Revision of Manuscript Number: IEEE-TPWRS-01391-2021, version 1 February 19, 2022

Journal: IEEE Transactions on Power Systems

Author: Abhishek Halder, Kenneth F. Caluya, Pegah Ojaghi, Xinbo Geng

Response to decision:

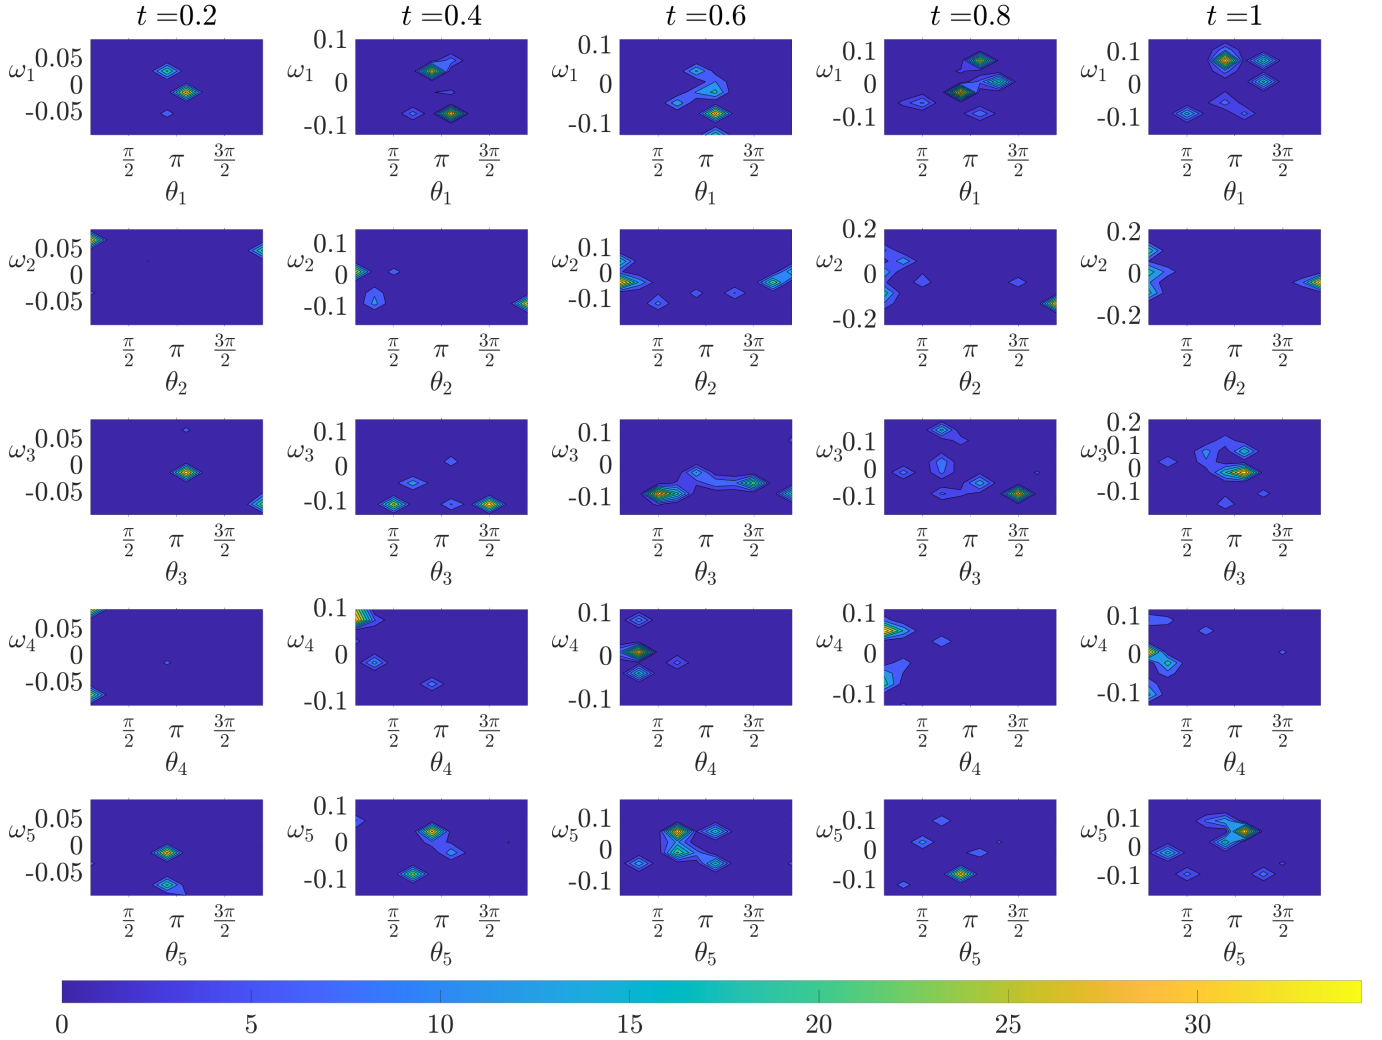
Figures 5 and 6 are unreadable.

Response: Thanks for this comment. In the previous version, the strict 10 page limit enforced small figure sizes. In the revised manuscript, Figures 5 and 6 are made larger. Also, the Fig. 6 in the revised manuscript shows the transient (θ_i, ω_i) bivariate marginals for all the five generators in Case II; the previous version showed the same only for the generator 4 (bus 6). We believe these changes have improved clarity.

Regarding the style of plots, we had considered plotting the bivariate marginals as planar contour plots (as in Fig. 1 in this rebuttal document) but decided against it because of the following two reasons.

First, in our opinion, this kind of plot is scientifically misleading as they hide the fact that these bivariate marginal PDFs are not really supported on the plane, or the subsets thereof, but instead have cylindrical supports. Our message that the proposed method explicitly accounts this manifold geometry in the computation, would be missed had we chosen to make the plots the other way.

Second, the planar contour marginal plots require additional mental efforts from the readers to correctly parse the statistical information conveyed. For instance, consider the fourth column, second row subplot in Fig. 1 in this rebuttal document. It is upon the reader to parse that the two high probability regions on the left and right of that subplot are actually referring to the same angular high probability region around $\theta_2 = 0$ rad, thanks to the periodic boundary condition on the angular variable. Our philosophy of technical communication is that the onus is on the authors, not on the readers, to clarify the scientific information as correctly as possible. We thus prefer to make plots that depict the variables as they are.
